BEFORE THE STATE OF WASHINGTON
ENERGY FACILITY SITING EVALUATION COUNCIL

Scout Clean Energy, LLC, for
Horse Heaven Wind Farm, LLC,
Applicant.

DOCKET NO. EF-210011

PRE-FILED TESTIMONY OF TCC
WITNESS PAUL KRUPIN

24 **The application does not contain maps of the project that identify micrositing**
25 **corridors and turbine numbers and locations suitable for a reasonably accurate**
26 **analysis of the impacts.**

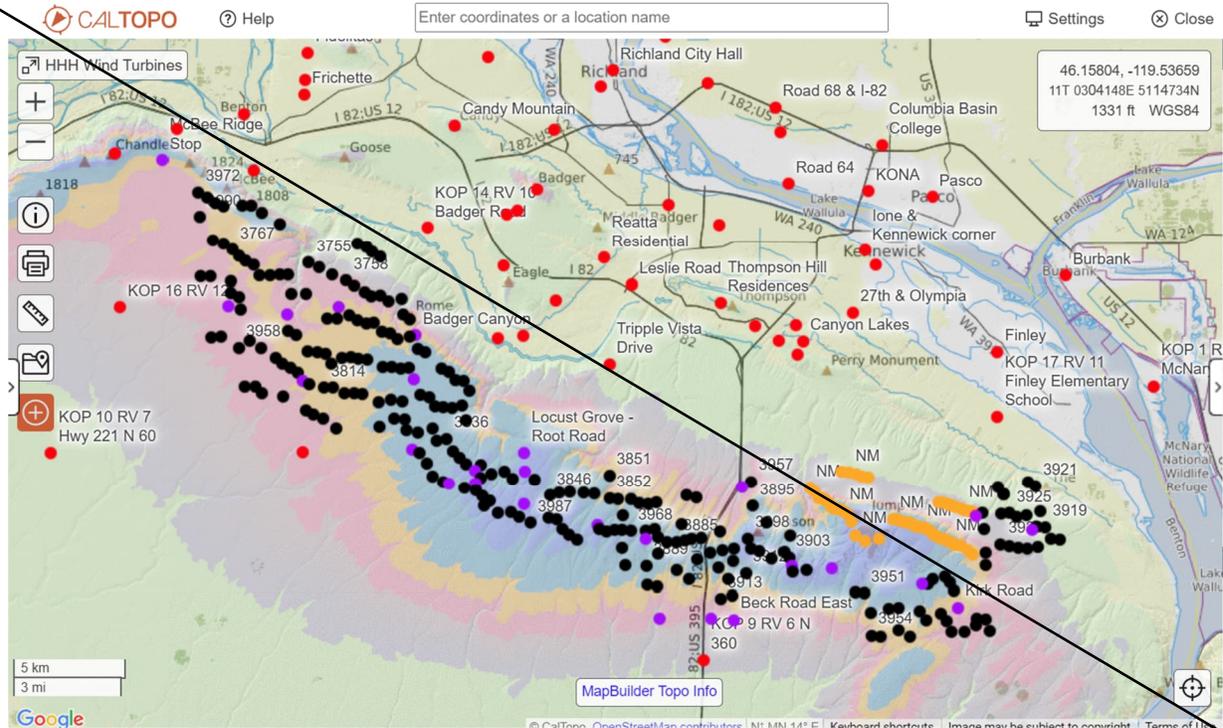
1 In particular, the lack of turbine numbers in the layout maps for Options 1 and Option
2 2 make it very difficult to identify and analyze conflicts with elements of the
3 environment.

5
6 The Visual Assessment Map Viewshed Analysis Results for Turbine Layout Option 1
7 is pretty much impossible to use for a reasonable evaluation of the visual impacts by
8 reviewers or by anyone in the affected areas.

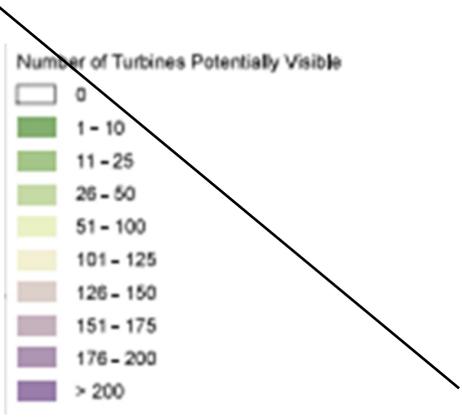
~~It is impossible to see the KOP's. It is impossible to read the KOP number.~~

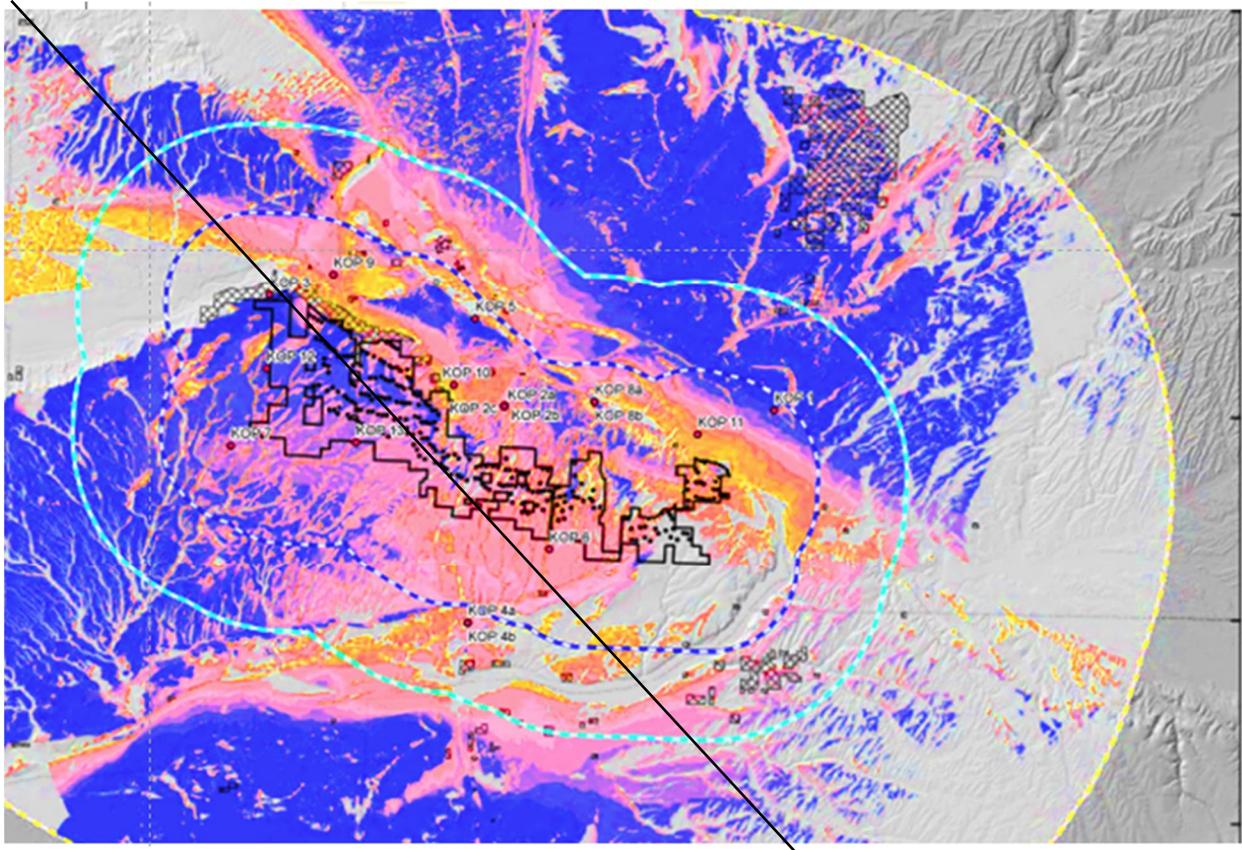
~~This was very confusing so one of the members of TCC used Photoshop to recolor the legend and the map using a color spectrum found on the National Weather Service maps for temperature and precipitation. These maps use a color spectrum that goes from light to dark corresponding to low to high values.~~

~~Even with the revised coloration, it is still extremely difficult to make reasonable use of this map. It is impossible to see the locations and details accurately.~~

7
 8 **Figure 13**
 9 **KOP 13**
 10 **RV9**
 11 **SE 195**

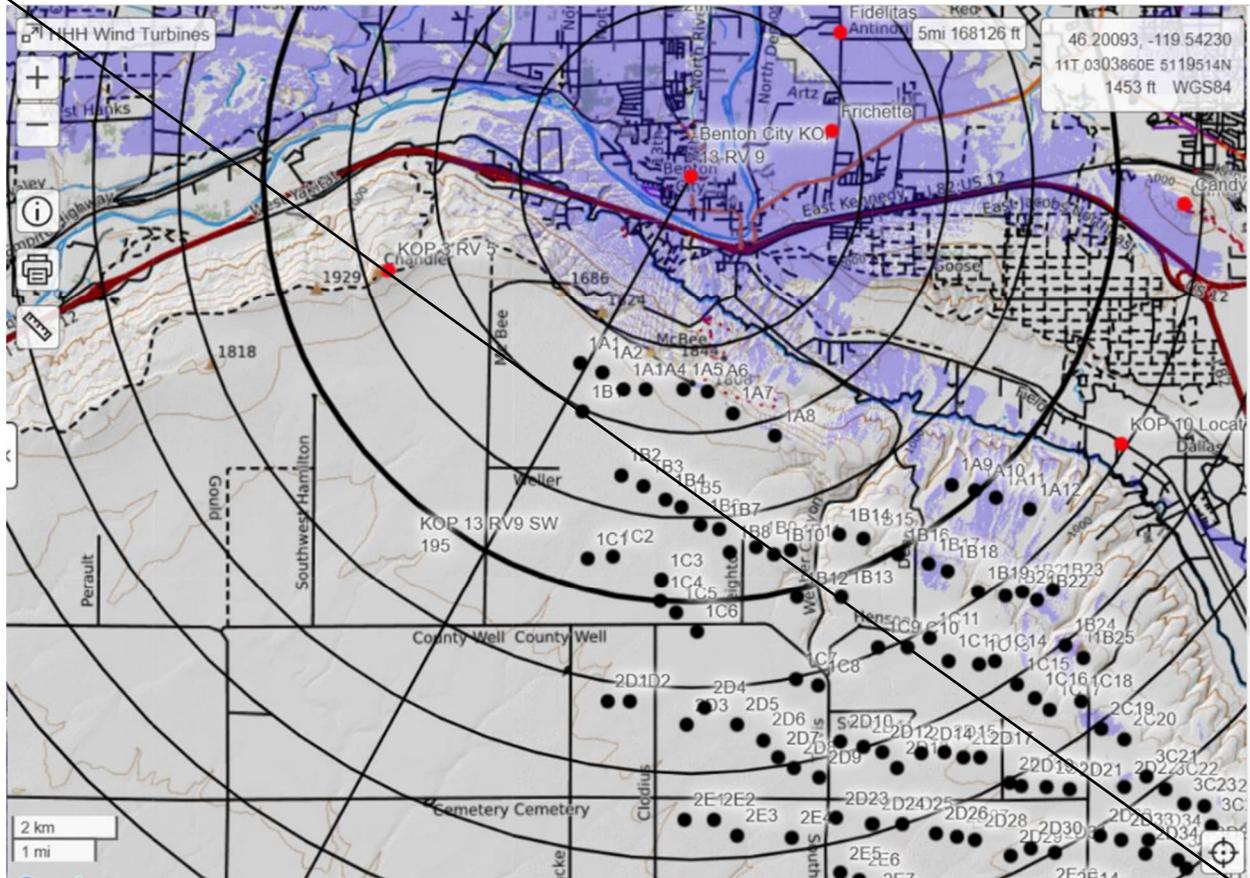
1 Here is the Viewshed provided in the Application taken from downtown Benton City
 2 The application simulation literally blocks and obscures the view of the project that will
 3 be seen from this location. The gas station sign and the trees obscuring more than
 4 half of the view in the photo and they analysis yields absolutely no information of value
 5 to the visual assessment. It's basically useless.

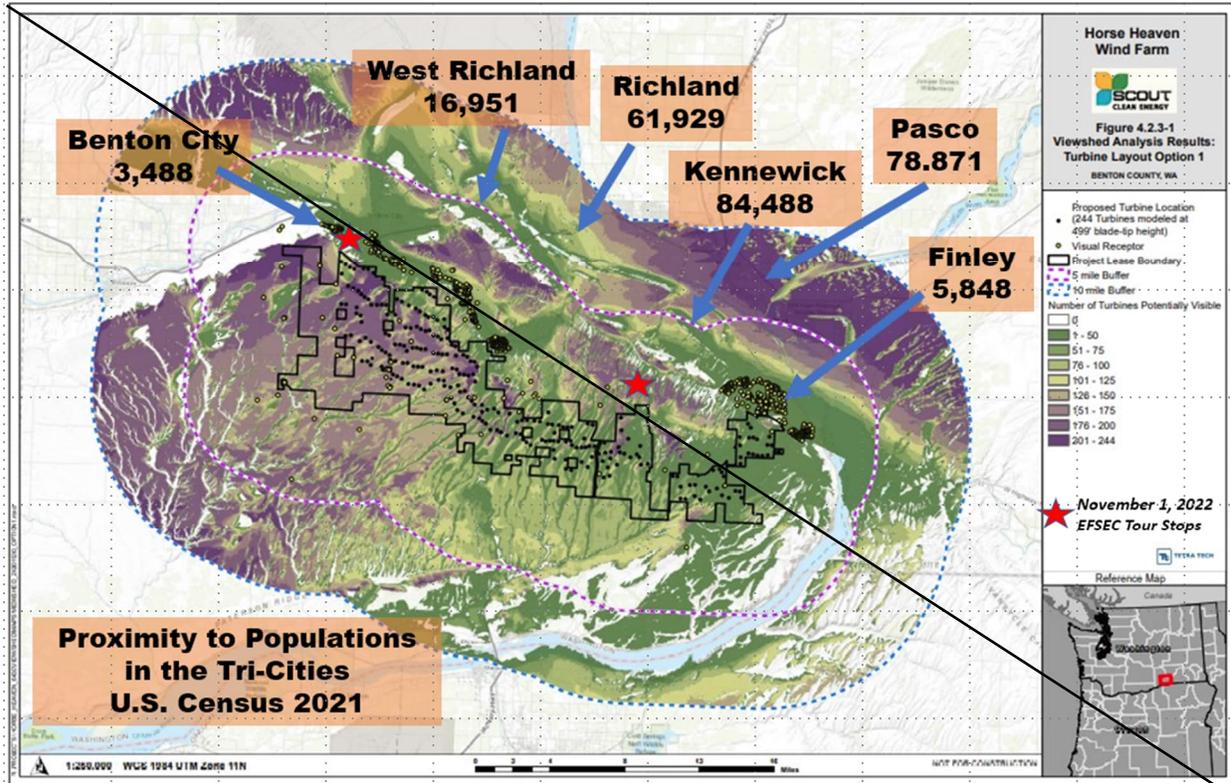
7
8 The November 1, 2022 Road tour to the Horse Heaven Hills Project did not provide
9 EFSEC with a reasonable means of describing, experiencing and evaluating the
10 proposed Project, the affected environment, the lack of alternatives, and the need for
11 mitigation measures to protect the environment.
12

13 Neither of the tour stop locations is on the HHH project property but are located about
14 a mile north of the project boundary. EFSEC members did not view the actual
15 proposed site locations and will not be able to gain a reasonable or realistic
16 description of what and where the applicant has proposed facilities. Basically, from
17 these locations, you will not be able to even set eyes on the actual project itself.
18

EFSEC needs to do another tour to revisit the site and actually get on the Project and see and understand first hand the disproportionate impact the Project has on the people in Tri-Cities and the degree to which the Project causes significant impacts.

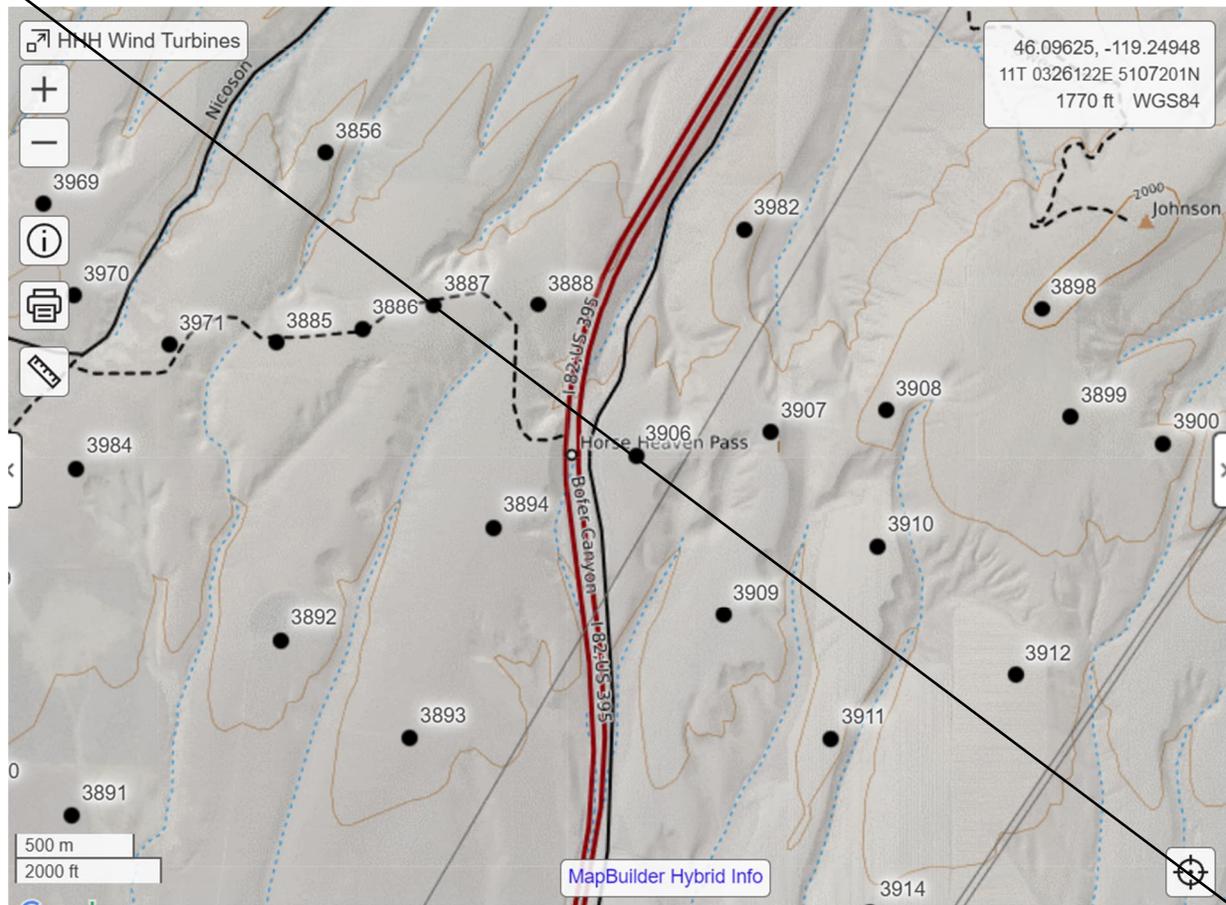
14
15
16 Using what is known, this yields $499 + 250 \times 1.5 = 1150$ feet plus the wind. The shape of
17 the ice and weight also make a difference. A piece of ice thrown from 499 feet in a 45
18 miles an hour wind could easily blow into cars on the highway.

19
20 It means that the proposed turbines on either side of Highway 395 can be a real hazard to
21 anyone driving from ice bombs travelling at 50 to 75 mph. Here's a reference from
22 General Electric.

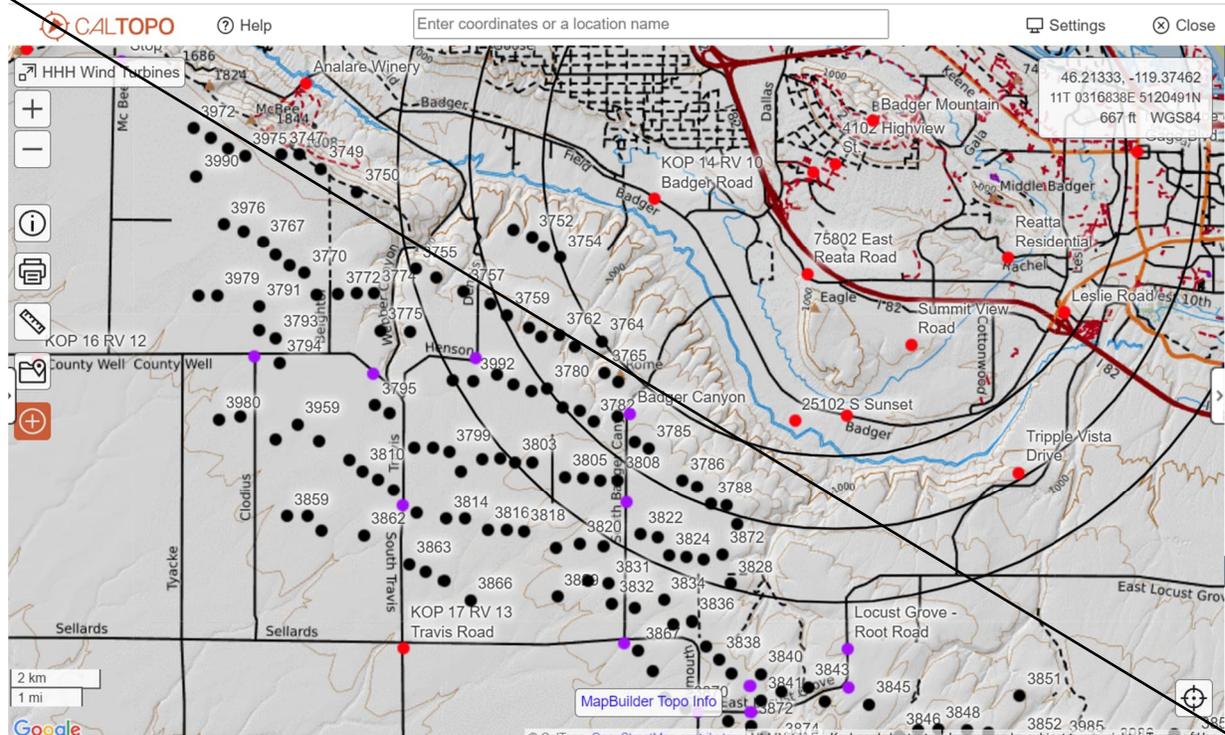
1 This graphic contains 4-mile, 5-mile, and six-mile range rings around the residential
2 Badger Mountain Estates residential community from 4102 Highview Street.

3
4 The turbines within the six-mile radius should be removed from consideration in the
5 project and deemed to close and intrusive to people due to the visual impact.

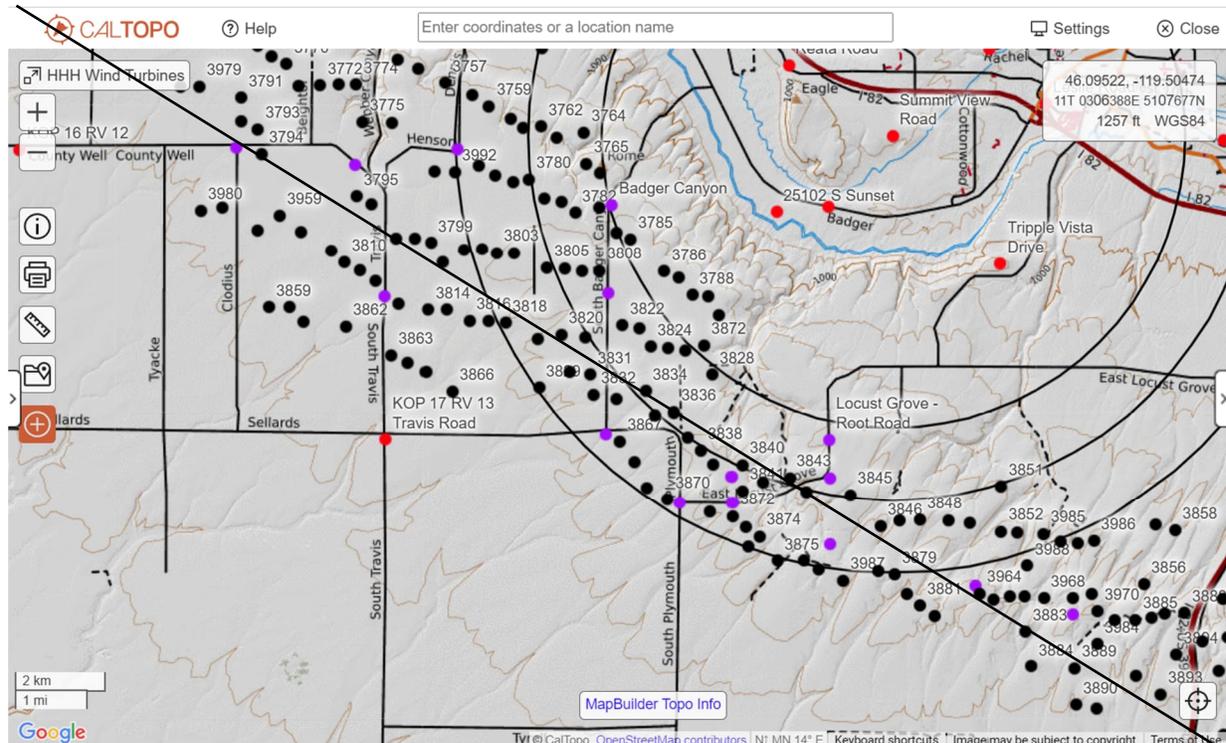
1 This graphic contains 4-mile, 5-mile, and six-mile range rings around the residential
2 the Summitview residential community from 40197 Summit View Road.

3
4 The turbines within the six-mile radius should be removed from consideration in the
5 project and deemed to close and intrusive to people due to the visual impact.

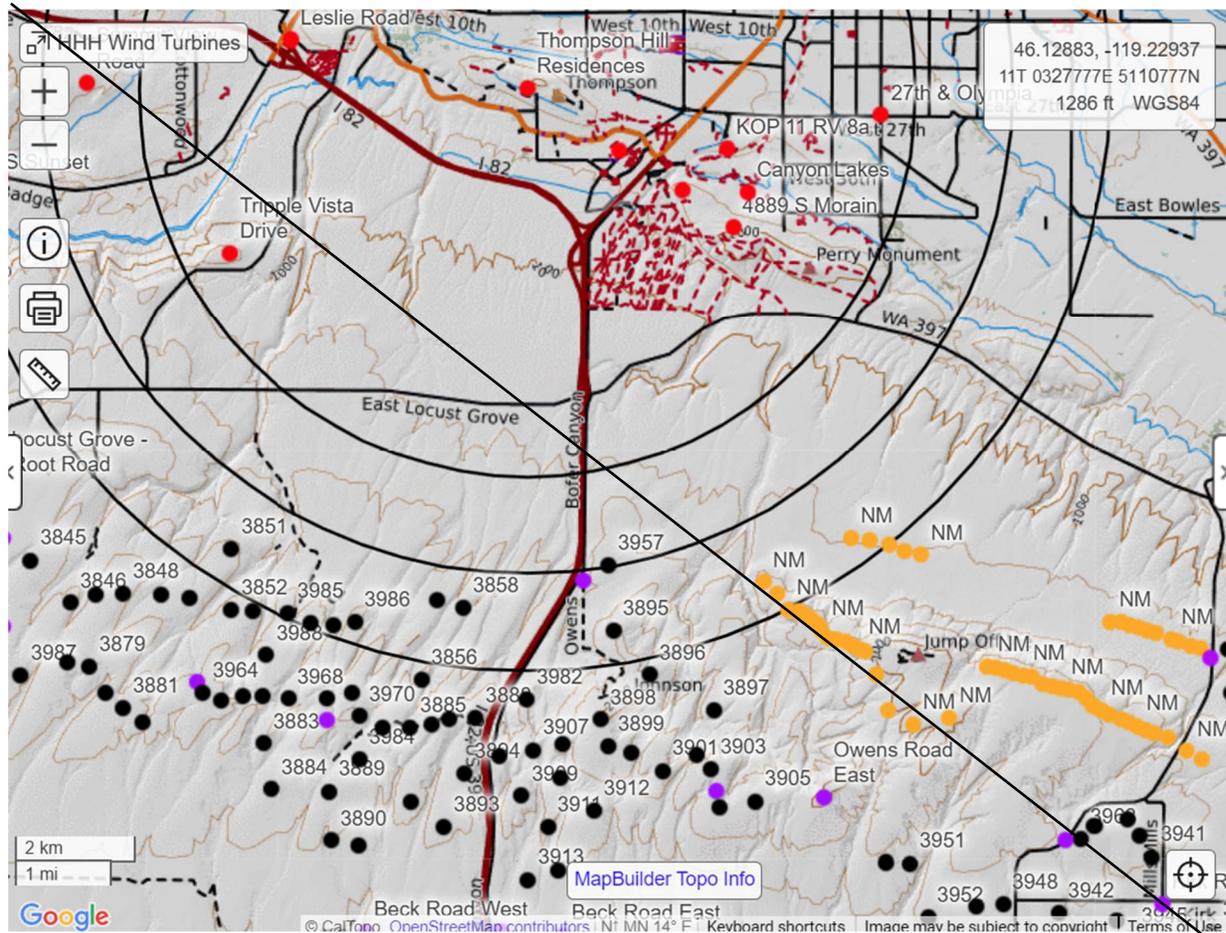
1 This graphic contains 4-mile, 5-mile, and six-mile range rings around the residential
2 the Symphony Ridge Development on Thompson Hill residential community from
3 South 26th St.

4
5 The turbines within the six-mile radius should be removed from consideration in the
6 project and deemed to close and intrusive to people due to the visual impact.

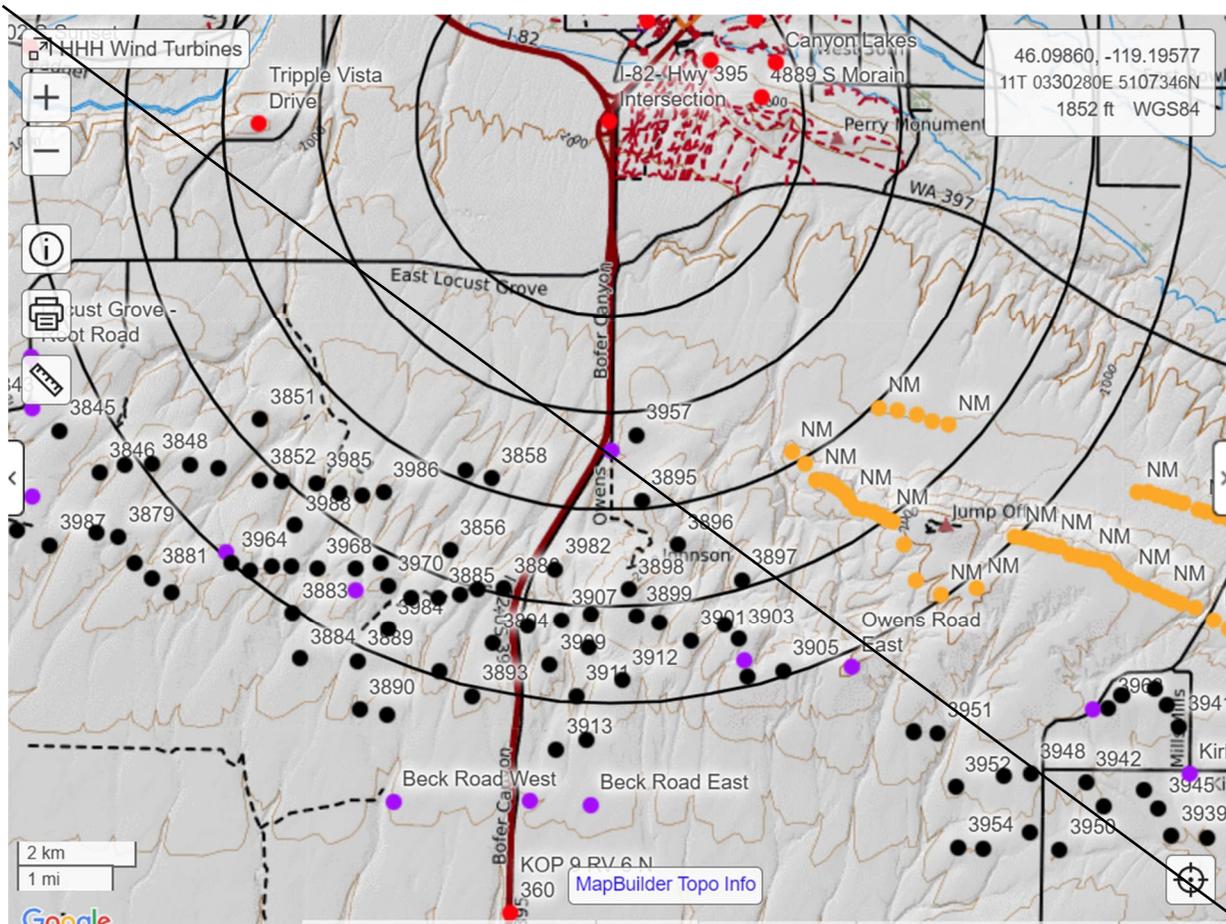
1 This graphic contains 2-mile, 3-mile, 4-mile, 5-mile, and 6-mile range rings around the
2 residential the intersection of Interstate 82 and Highway 395.

3
4 The graphic clearly shows the distances to the existing Nine Mile Canyons and the
5 locations of turbines that are within a comparable distance. Given the future growth
6 and development in South Kennewick, the turbines within the six-mile radius should
7 be removed from consideration in the project and deemed to close and intrusive to
8 people due to the visual impact.
